# Foxground and Berry bypass

Princes Highway upgrade

MAY 2013 REFINED CONCEPT DESIGN

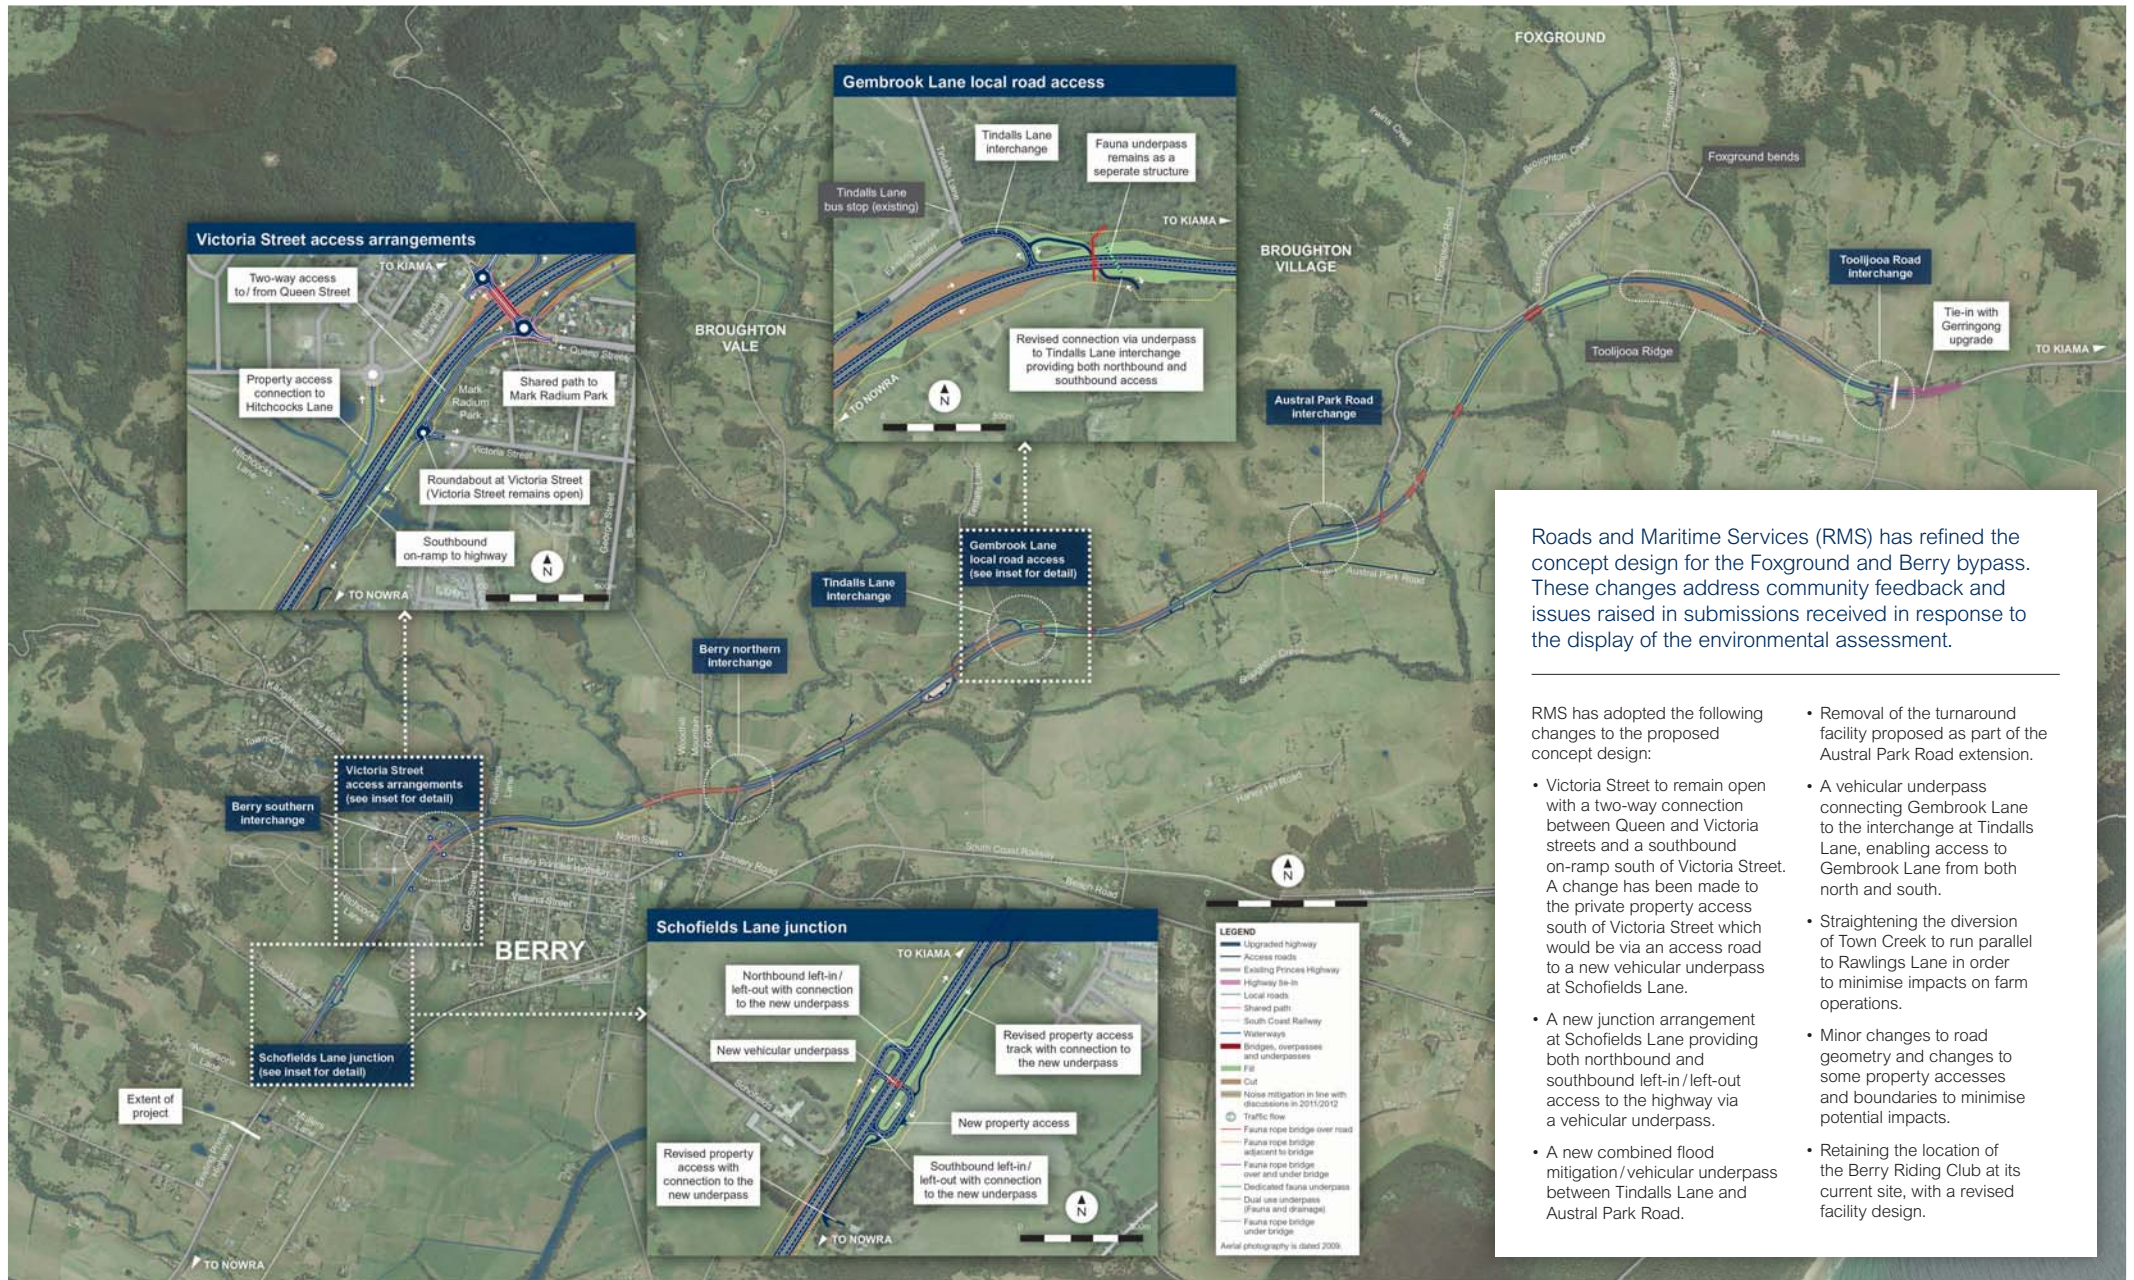
- Victoria Street to remain open with a two-way connection between Queen and Victoria streets and a southbound on-ramp south of Victoria Street. A change has been made to the private property access south of Victoria Street which would be via an access road to a new vehicular underpass at Schofields Lane.

- A new junction arrangement at Schofields Lane providing both northbound and southbound left-in/left-out access to the highway via a vehicular underpass.

- A new combined flood mitigation/vehicular underpass between Tindalls Lane and Austral Park Road.
- Removal of the turnaround facility proposed as part of the Austral Park Road extension.

- A vehicular underpass connecting Gembrook Lane to the interchange at Tindalls Lane, enabling access to Gembrook Lane from both north and south.
- Straightening the diversion of Town Creek to run parallel to Rawlings Lane in order to minimise impacts on farm operations.

- Minor changes to road geometry and changes to some property accesses and boundaries to minimise potential impacts.
- Retaining the location of the Berry Riding Club at its current site, with a revised facility design.
